CONTRACTOR QUESTIONS & ANSWERS – 2nd RESPONSE

Fort Apache Home of Harmony Project

January 18, 2024

(A) AT EXISTING CONCRETE WALL

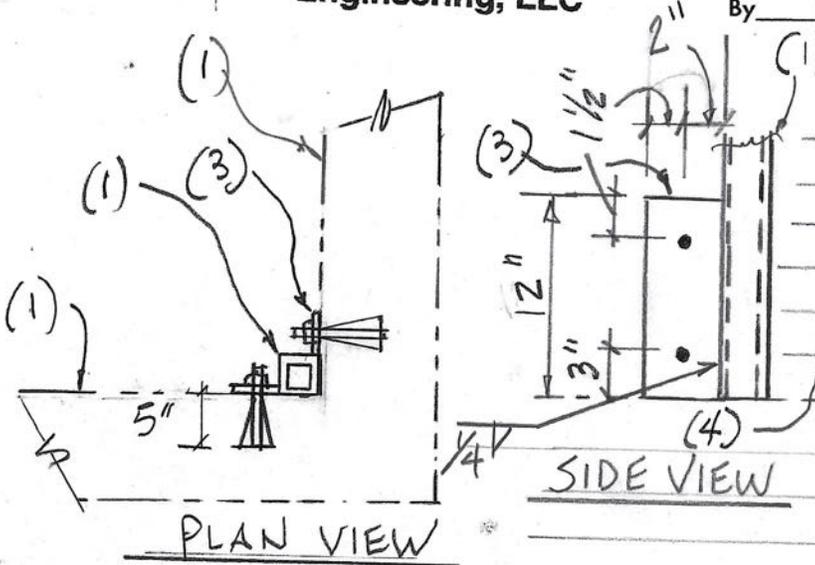
1. S2.01 Calls for a new column for the stairs with a callout for detail #412; however, detail 412 is missing. Please advise.

Structural has provided the missing detail #412 – see attached Exhibit A.

1. EXISTING CONC. WALL
2. STEEL COL. PER PLAN.
3. 3/8" STEEL CONNECTION PLATES WITH HOLES AS SHOWN, WITH 2 - 3/4" ϕ ICC RATED EXPANSION BOLTS.
4. TOP OF EXISTING CONCRETE SLAB ON GRADE.
